3.7 PLANT SYSTEMS

3.7.17 Spent Fuel Assembly Storage

ENCLOSURE 2

Revised Technical Specifications Bases

Figure 3.7.17-1
ASSEMBLY BURNUP VERSUS INITIAL ENRICHMENT
for
Region 2

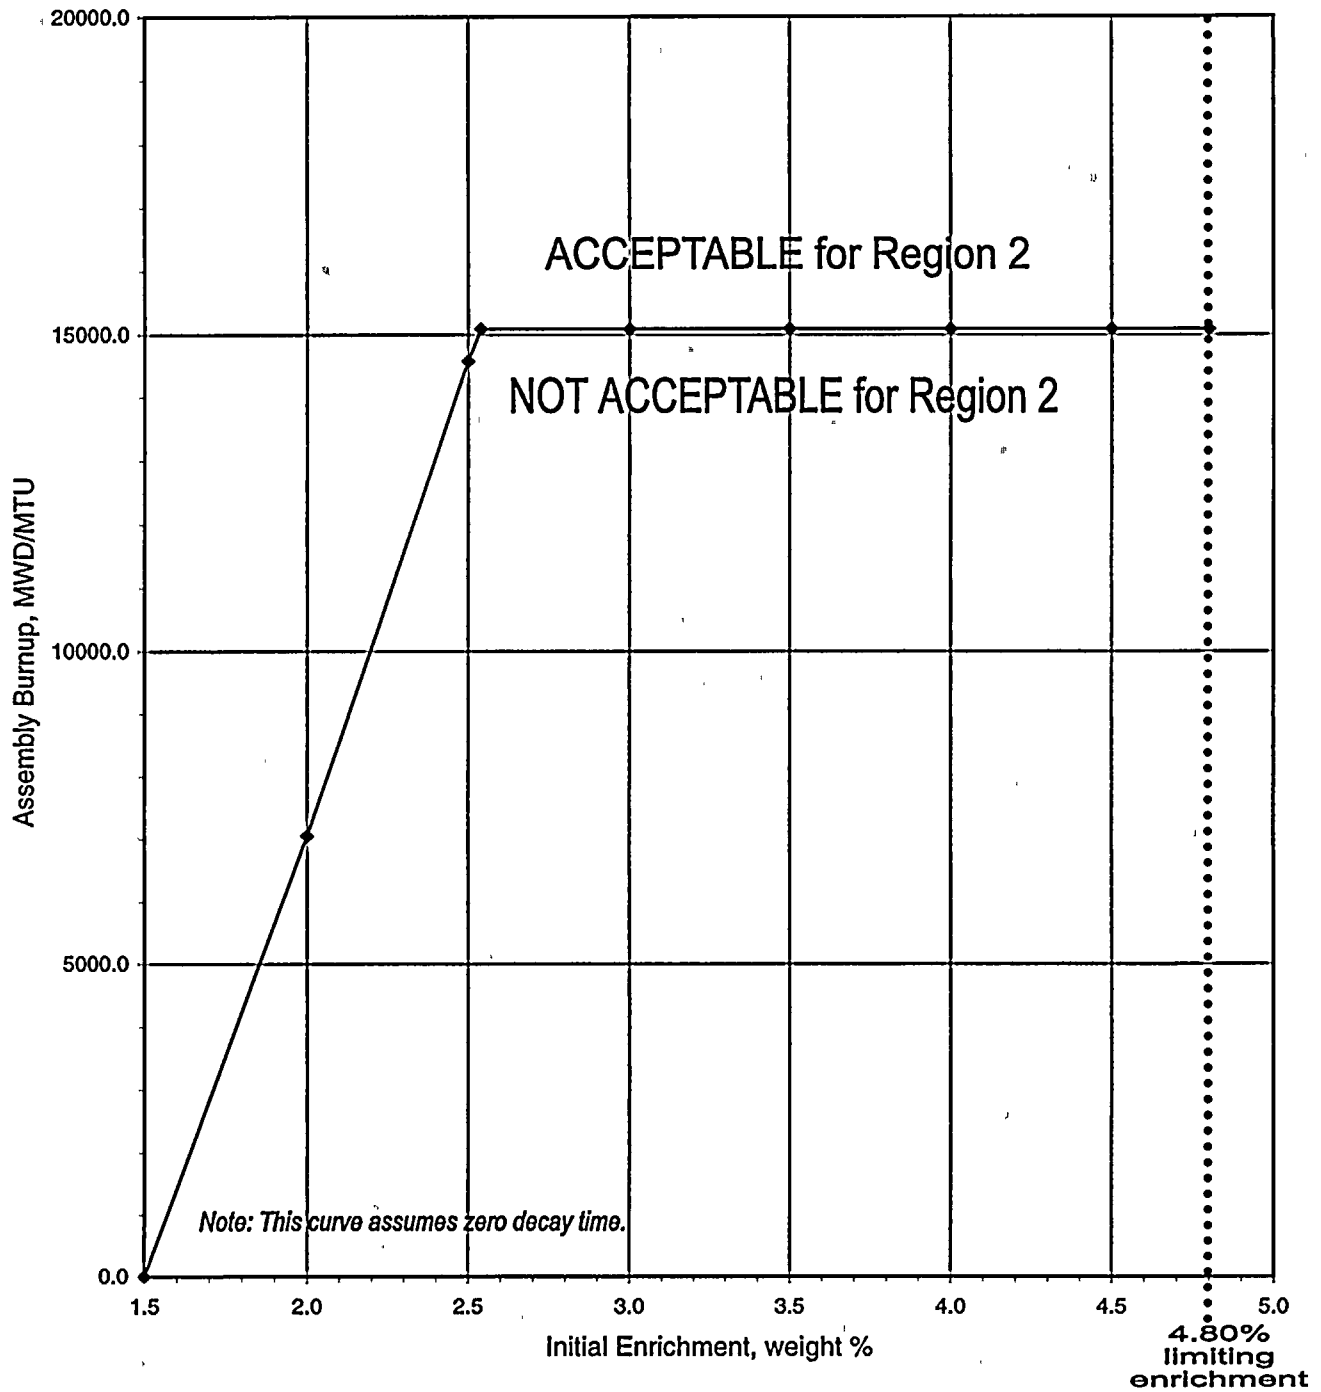
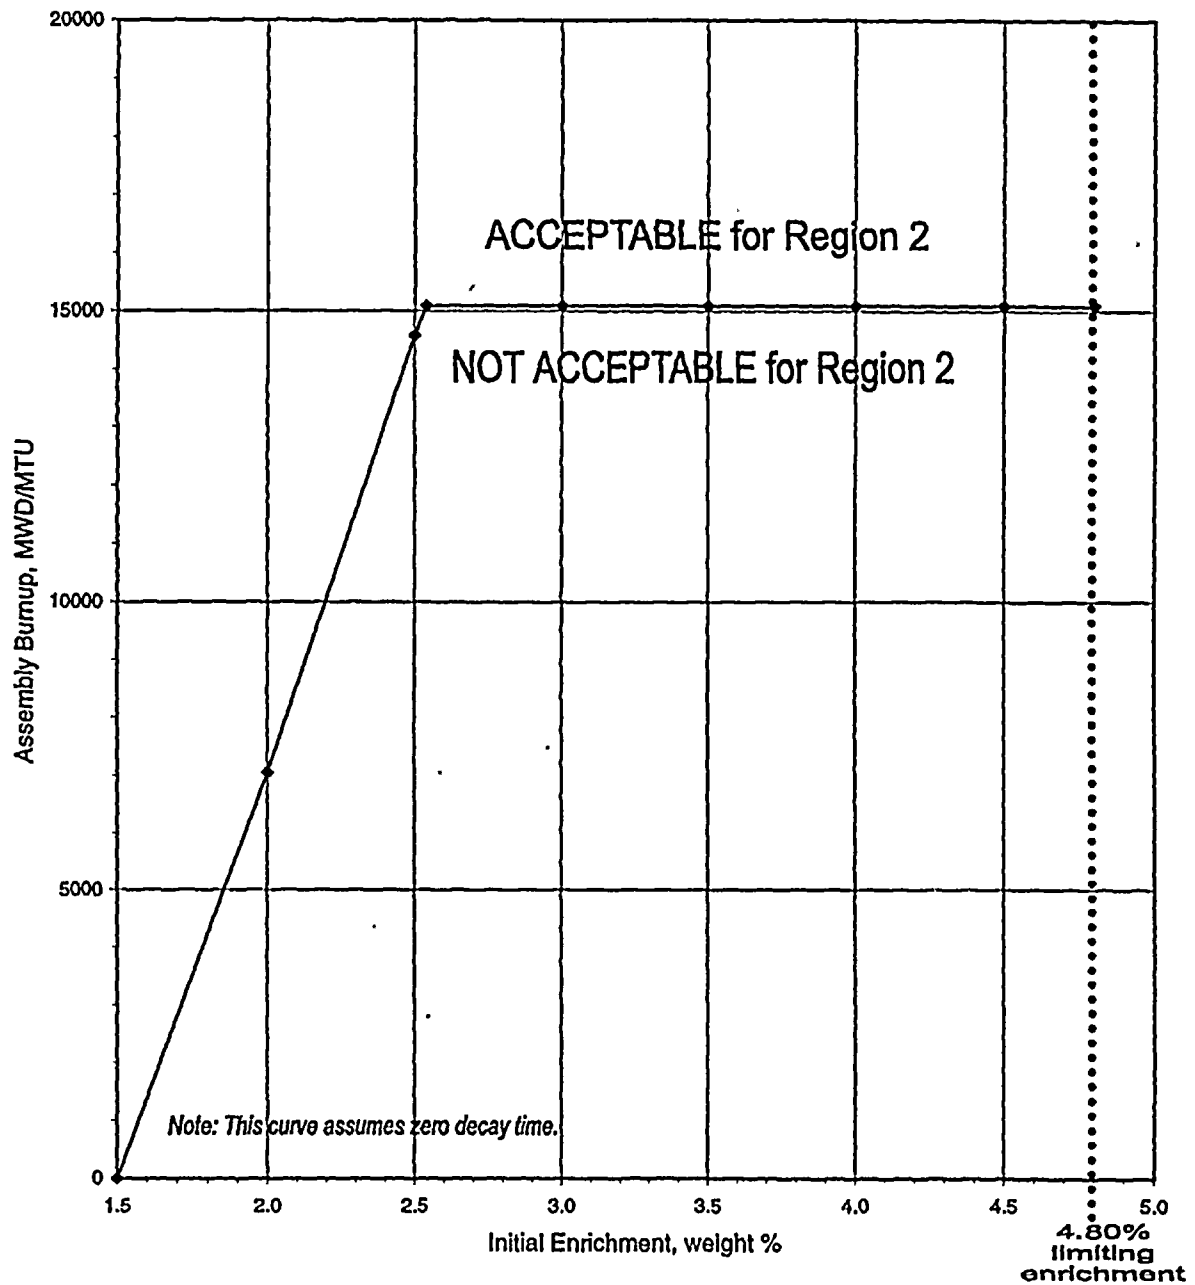
The combination of initial enrichment, ~~and~~ burnup of each fuel assembly stored in each of the ~~three~~ regions of the fuel storage pool shall be within the acceptable burnup domain for each region as shown in Figures 3.7.17-1 and described in Specification 4.3.1.1.

, and decay time

four

, 3.7.17-2, or 3.7.17-3,

→ Insert new Figures 3.7.17-1, 3.7.17-2, and 3.7.17-3 (pages 3.7.17-2, 3.7.17-3, and 3.7.17-4)

LCO 3.7.17 The combination of initial enrichment, burnup, and decay time of each fuel assembly stored in each of the four regions of the fuel storage pool shall be within the acceptable burnup domain for each region as shown in Figures 3.7.17-1, 3.7.17-2, or 3.7.17-3, and described in Specification 4.3.1.1.

Figure 3.7.17-2
ASSEMBLY BURNUP VERSUS INITIAL ENRICHMENT
for
Region 3
(at decay times from 0 to 20 years)

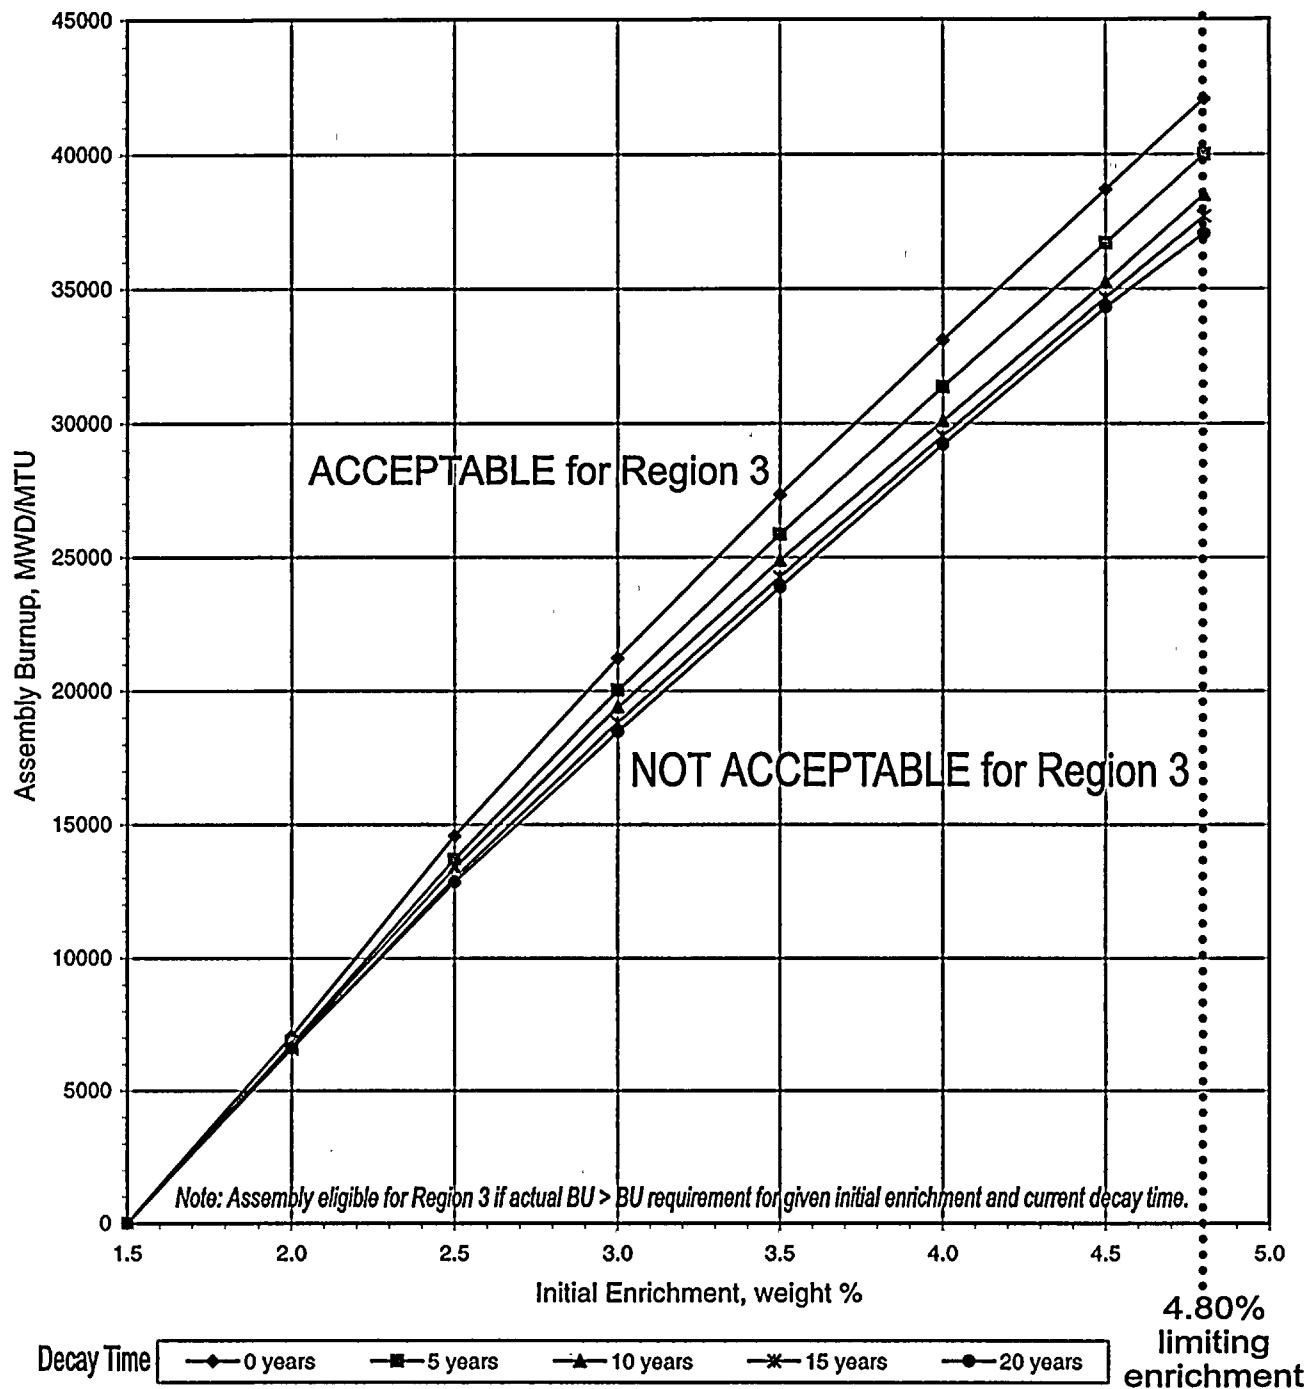
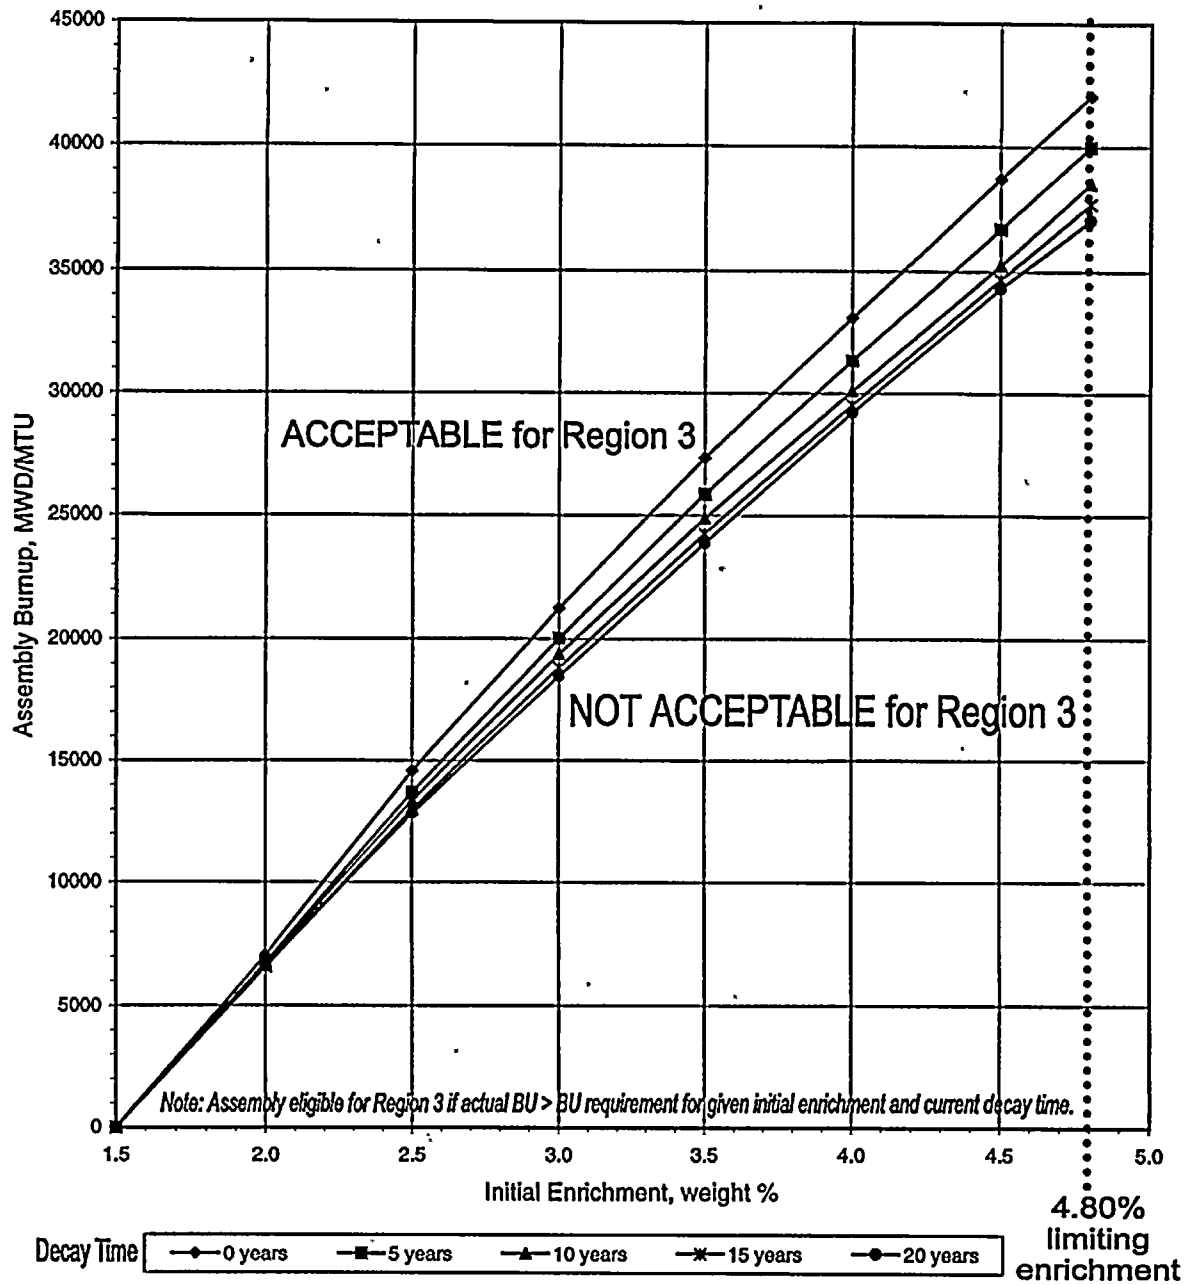
KENO-Va calculations were used to construct curves of burnup versus initial enrichment for decay times in 5 year increments from 0 to 20 years for both Regions 3 and 4 (TS Figures 3.7.17-2 and 3.7.17-3) such that all points on the curves produce a k_{eff} value (including all biases and uncertainties) of <1.0 for unborated water. Biases associated with methodology and water temperature were included, and uncertainties associated with methodology, KENO-Va calculation, fuel enrichment, fuel rack pitch, fuel rack and L-insert thickness, pellet stack density, and asymmetric fuel assembly loading were included. KENO-Va calculations were also performed to determine the soluble boron concentration required to maintain the spent fuel pool k_{eff} (including all biases and uncertainties) ≤ 0.95 at a 95% probability/95% confidence level. A soluble boron concentration of 900 ppm is required to assure that the spent fuel pool k_{eff} remains ≤ 0.95 at all times. This soluble boron concentration accounts for the positive reactivity effects of the most limiting single fuel mishandling event and uncertainties associated with fuel assembly reactivity and burnup. This method of reactivity equivalencing has been accepted by the NRC (Reference 3) and used for numerous other spent fuel storage pools that take credit for burnup, decay time, and soluble boron.

Figure 3.7.17-3
ASSEMBLY BURNUP VERSUS INITIAL ENRICHMENT
for
Region 4
(at decay times from 0 to 20 years)

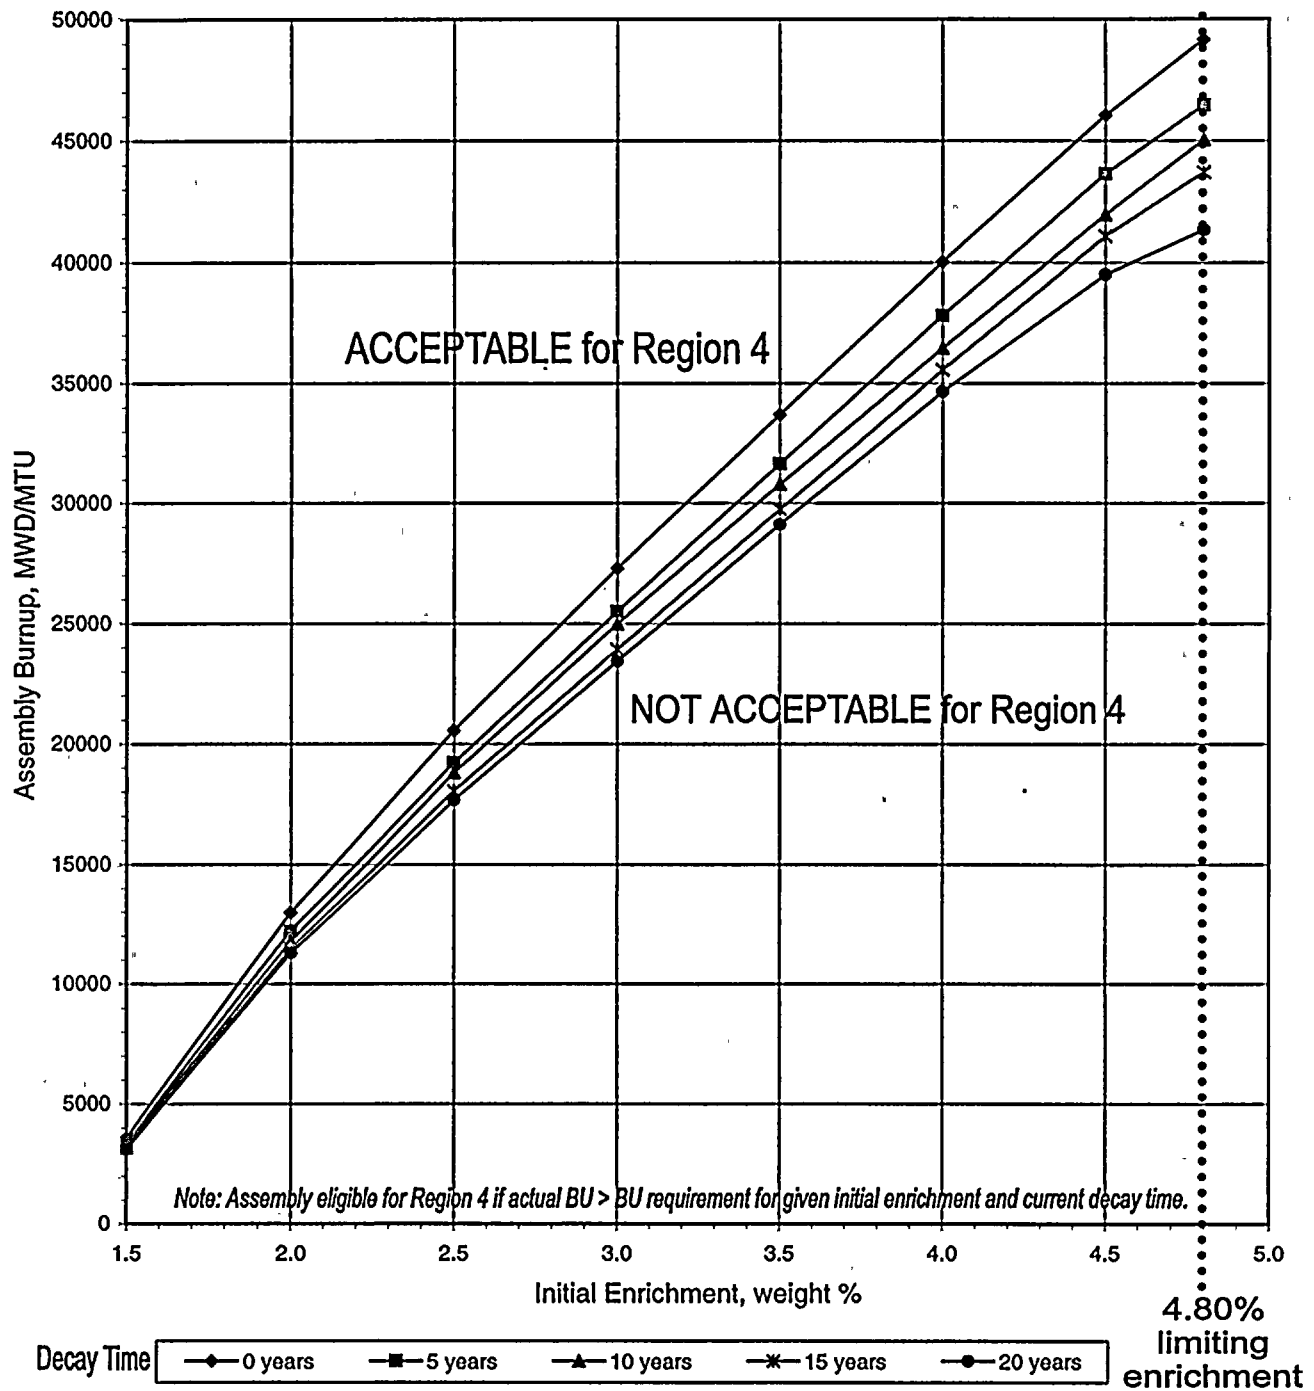
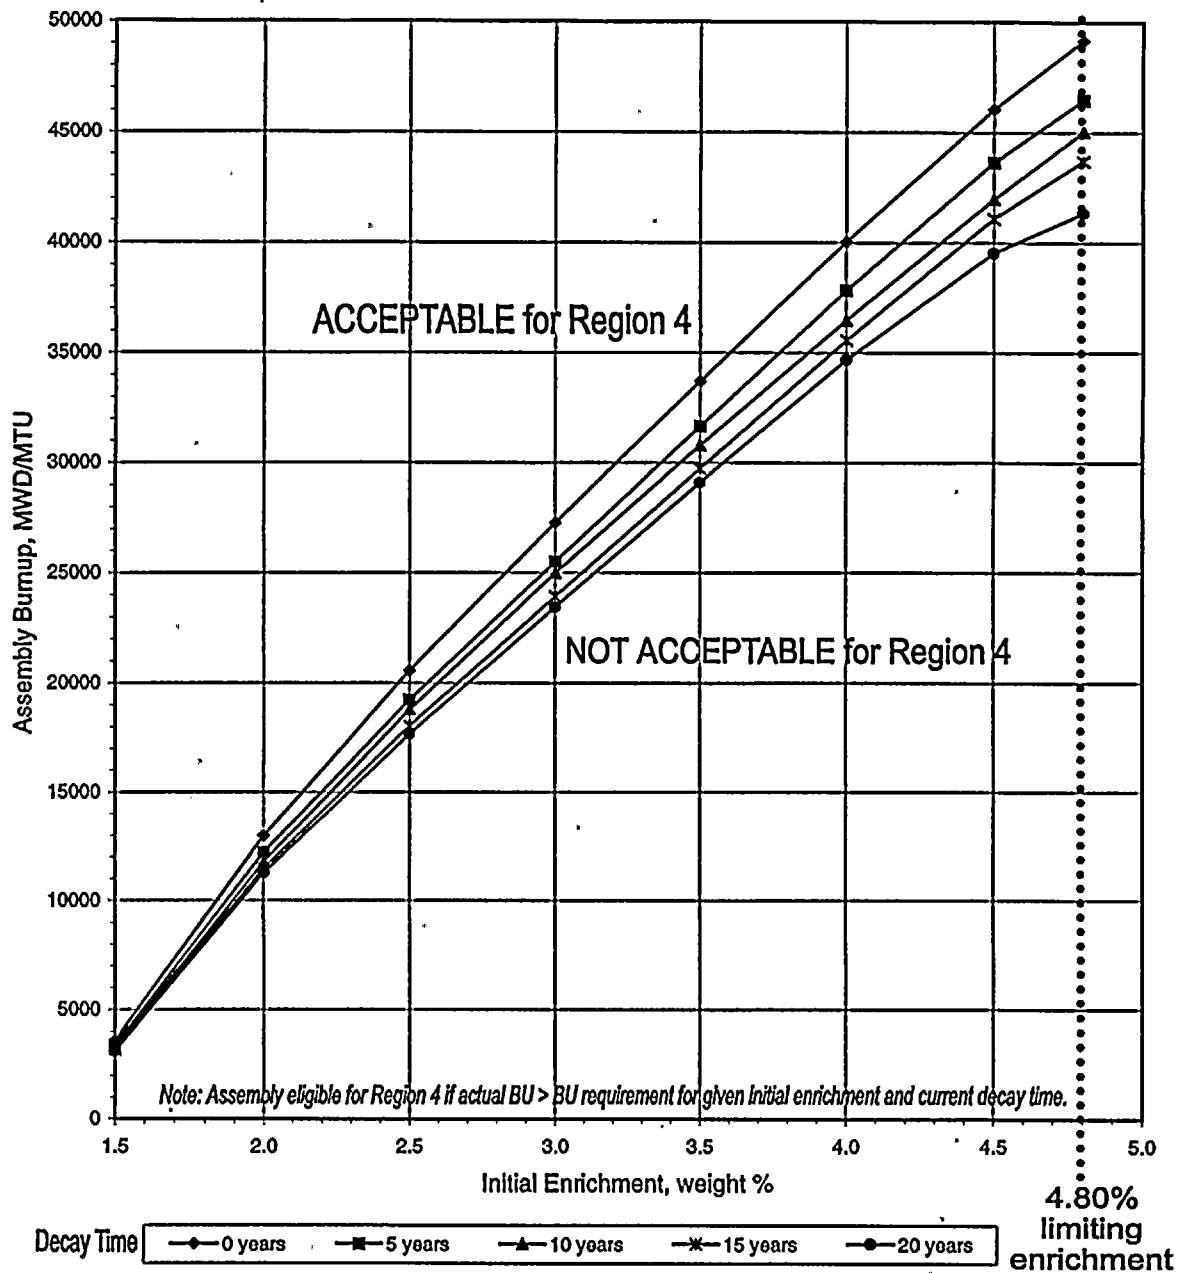
- h. Region 4: Fuel shall be stored in a repeating 3-by-4 storage pattern in which Region 2 (two-out-of-twelve) assemblies and Region 4 (ten-out-of-twelve) assemblies are mixed as shown in Section 9.1 of the UFSAR. Only fuel that qualifies to be stored in Region 4 in accordance with Figure 3.7.17-3 shall be stored in Region 4.

- h. Region 4: Fuel shall be stored in a repeating 3-by-4 storage pattern in which Region 2 (two-out-of-twelve) assemblies and Region 4 (ten-out-of-twelve) assemblies are mixed as shown in Section 9.1 of the UFSAR. Only fuel that qualifies to be stored in Region 4 in accordance with Figure 3.7.17-3 shall be stored in Region 4.
